Docket Item # 5  
BAR CASE #2006-0124

**ISSUE:** Additions and alterations

**APPLICANT:** Chris & Patsy Randolph by Robert B. Adams & Associates

**LOCATION:** 5 Potomac Court

**Figure 1** - Proposed north elevation

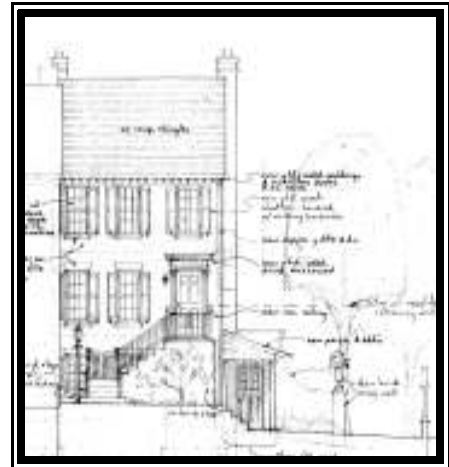
- 1) The shed dormer with the copper sides, which is discouraged in the guidelines;
- 2) The front porch with the copper roof which interrupts the symmetry of the facade;
- 3) The dominant bay windows on the rear elevation. These, in conjunction with the dormer, drastically alter the appearance of the facade.

**Figure 3** - Proposed south elevation

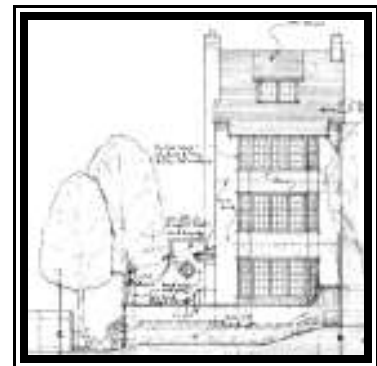
The three story bay will be a large and striking new feature on the house and will be readily visible from Windmill Hill Park. Staff believes the color of the stucco on the bay should be in a darker tone close to the brick color to minimize its visibility. The stucco color should be submitted to Staff for review and approval.

Staff recommends approval of the application with the following conditions:

1. The stucco color must be submitted to Staff for review and approval;
2. The following statements must be included in the General Notes of all site plans, as well as on all site plan sheets that include ground disturbing actions:  
Contact Alexandria Archaeology (703-838-4399) two weeks prior to any ground disturbing activity (such as coring, grading, filling, vegetation removal, undergrounding utilities, pile driving, landscaping and other excavations as defined in Section 2-151 of The Zoning Ordinance) on this property. City archaeologists will provide on-site inspections to record significant finds; and,  
Call Alexandria Archaeology (703/838-4399) immediately if any buried historic structural remains (wall foundations, cisterns, wells, privies, etc.) or concentrations of artifacts are discovered during development. Work must cease in the area of the discovery until a City archaeologist comes to the site to record the finds.
